THE SHERWIN-WILLIAMS COMPANY
Environmental, Health & Regulatory Services
101 Prospect Avenue NW
Cleveland, Ohio 44115-1075
Facsimile: (216) 566-2730

RE: Sherwin-Williams/Hilliards Creek Site- Former Manufacturing Plant
Gibbsboro, New Jersey
Administrative Order Index No. II CERCLA-02-99-2035

Response to USEPA and NJDEP May 2, 2012 Comments on
January 20, 2012 *Revised Work Plan for Additional
Groundwater Characterization*

MIP-17

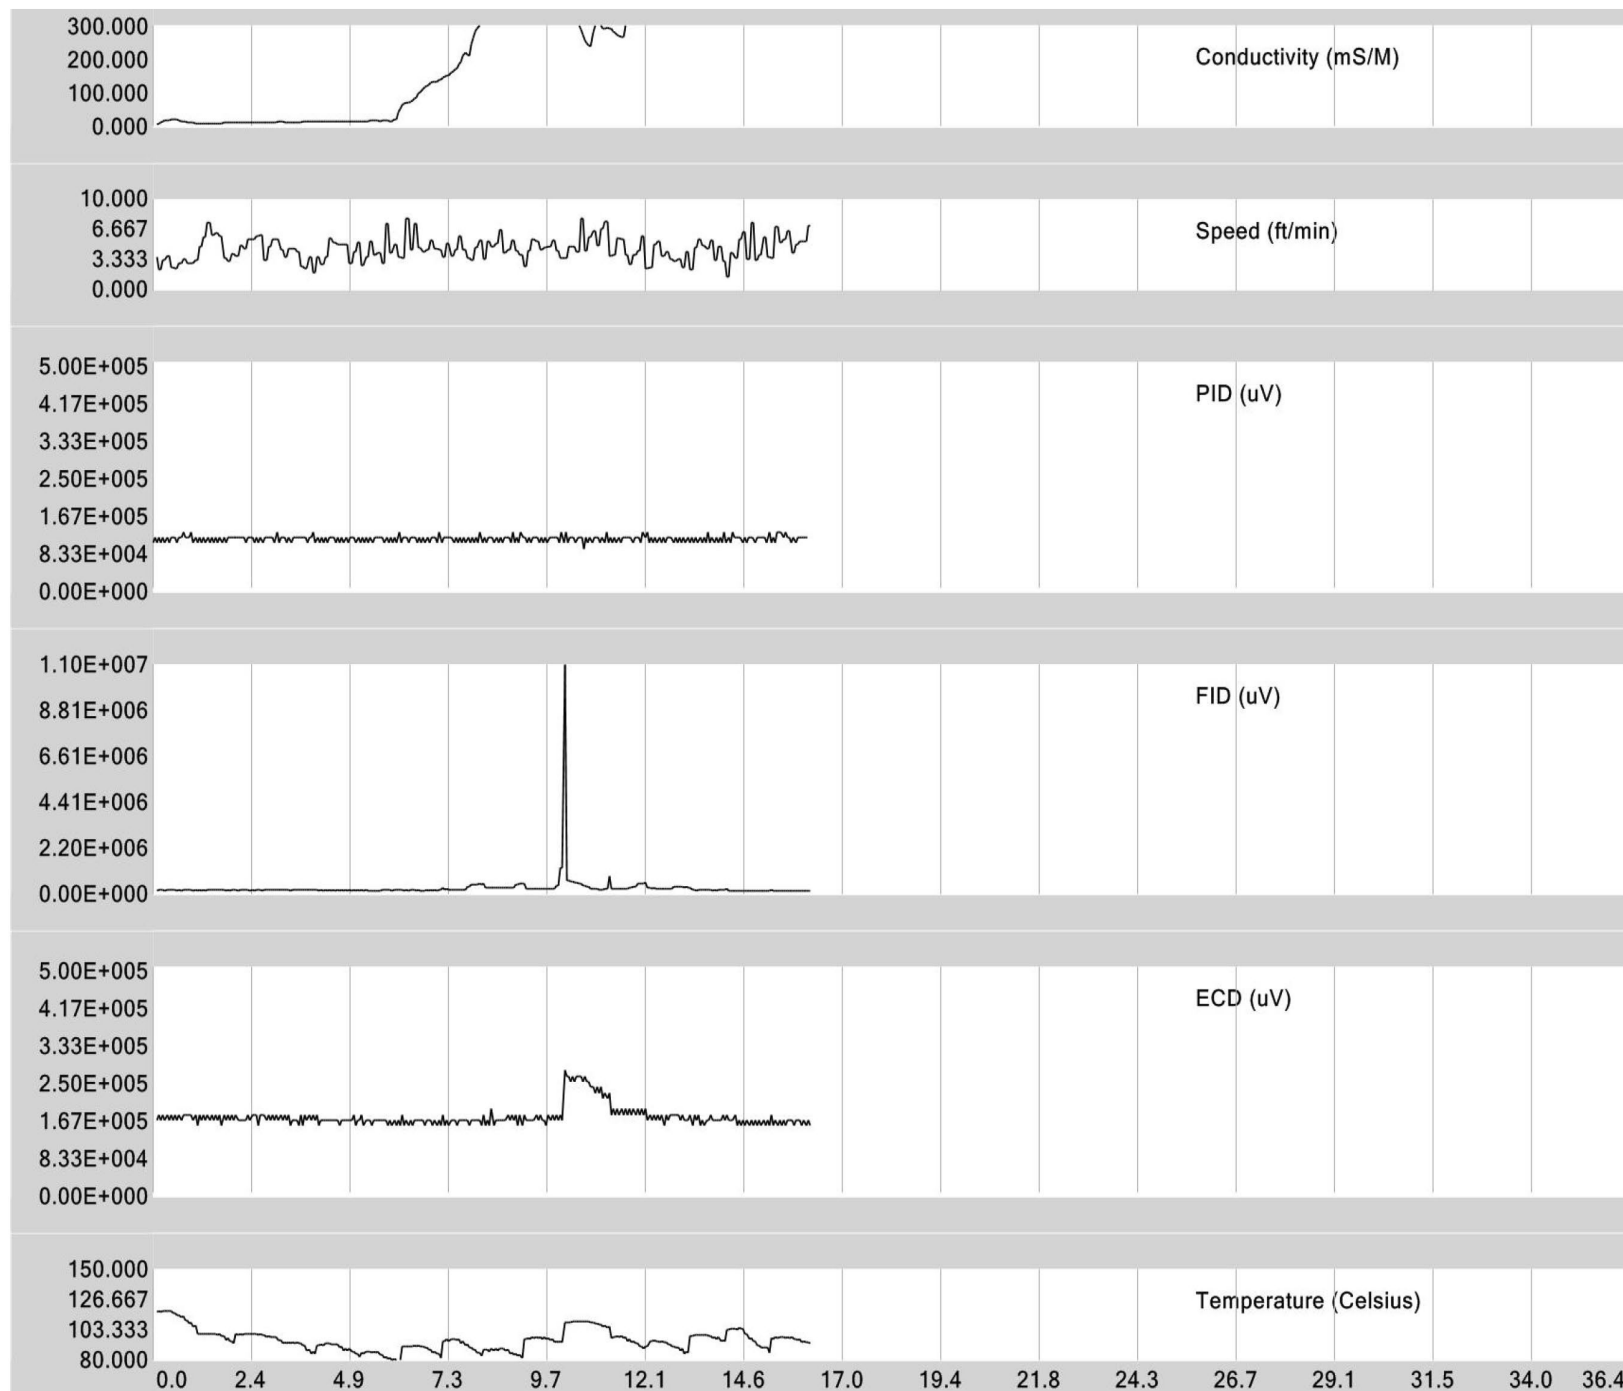
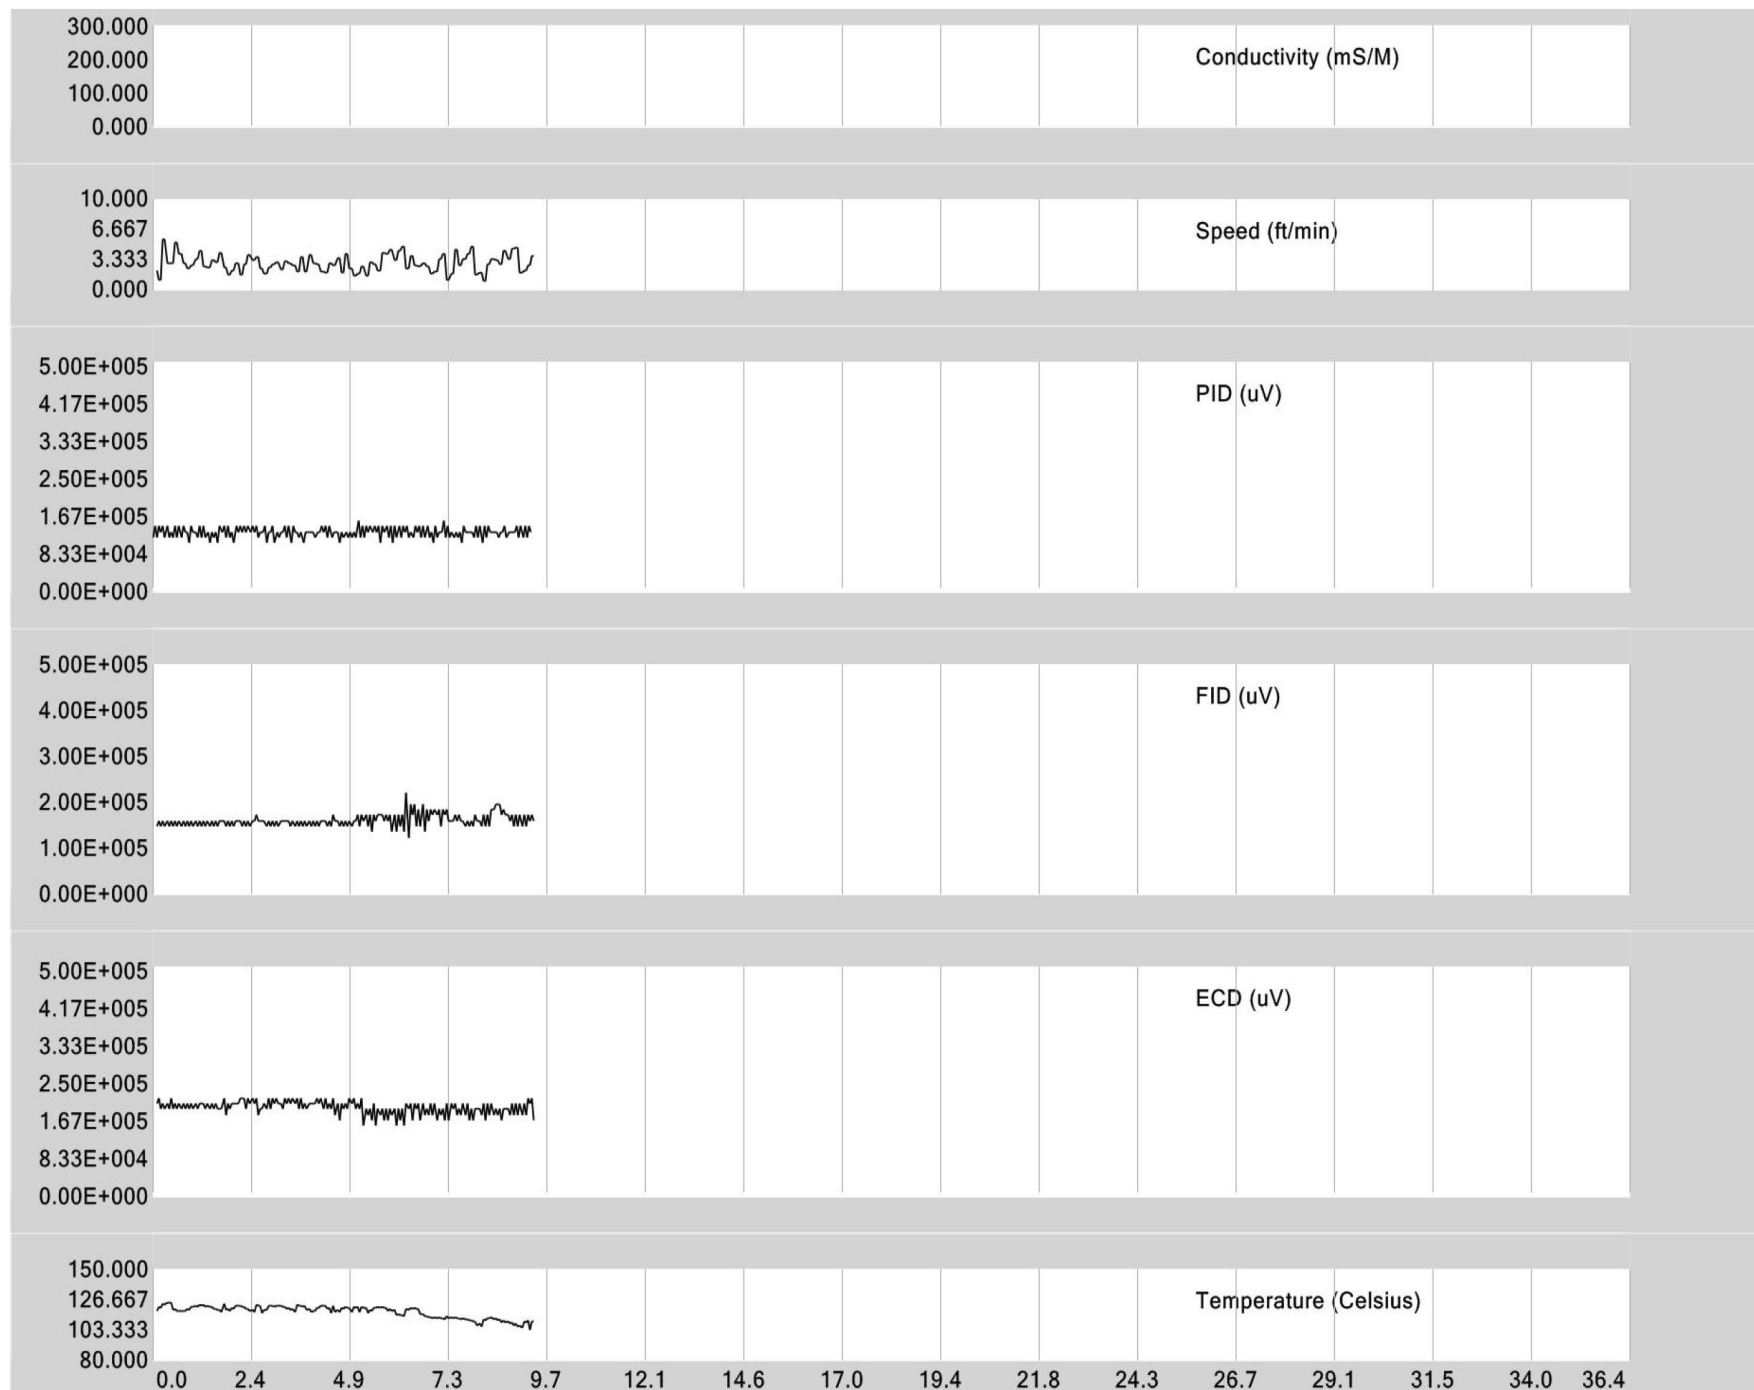
On the log of MIP-17, there is a clear spike at a depth of approximately 10 feet in both the FID and ECD readings, indicating the presence of volatile organic compounds (VOCs) at this depth. There was no PID response, suggesting that the VOC was likely a chlorinated solvent, and the PID lamp may not have been properly sized to detect the VOC.

CPT-06

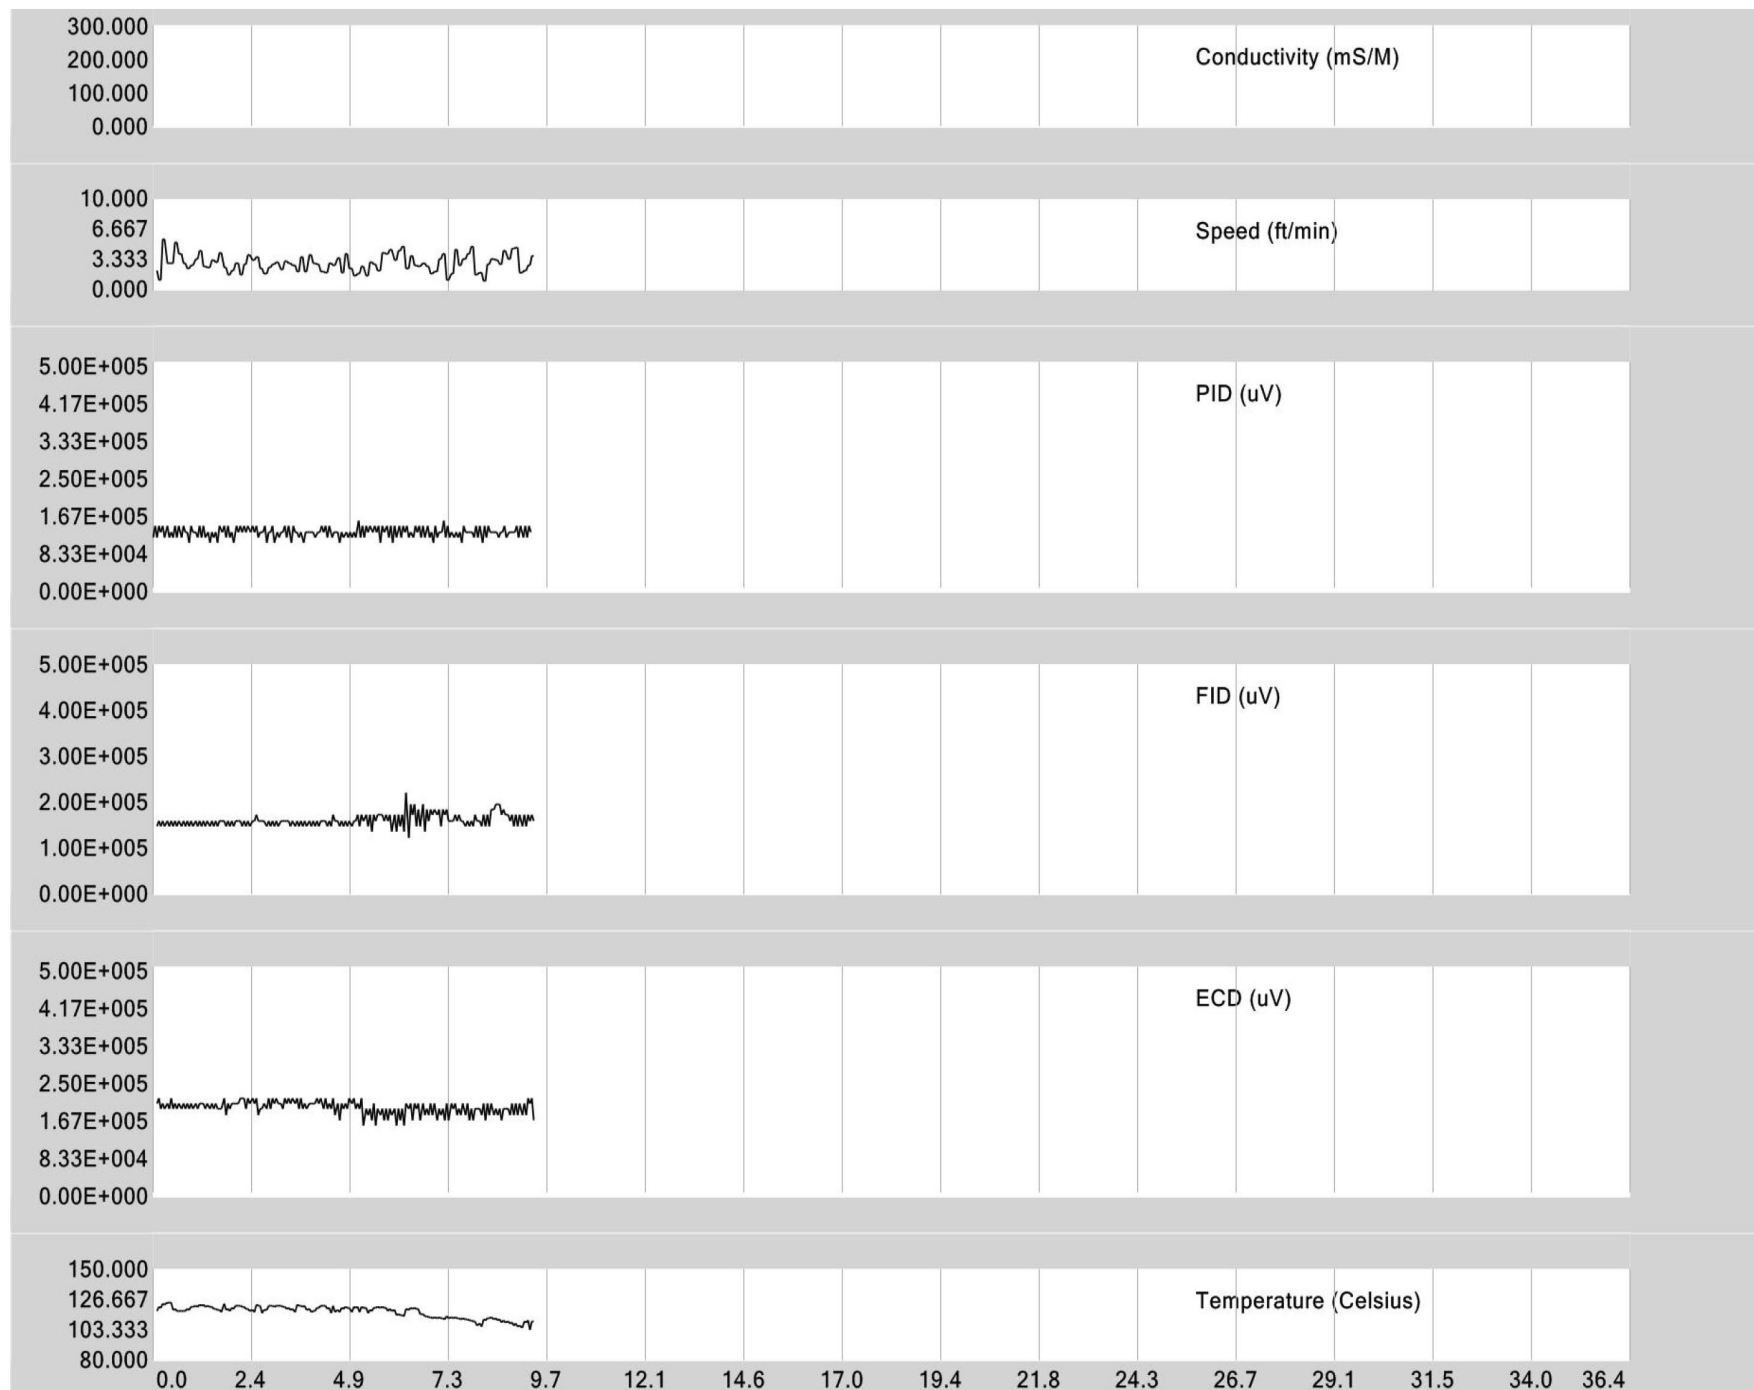
Conversely, as shown on the log for CPT-06, there was no response in any of the three indicators of the presence of contamination. In this case, no VOCs were detected.
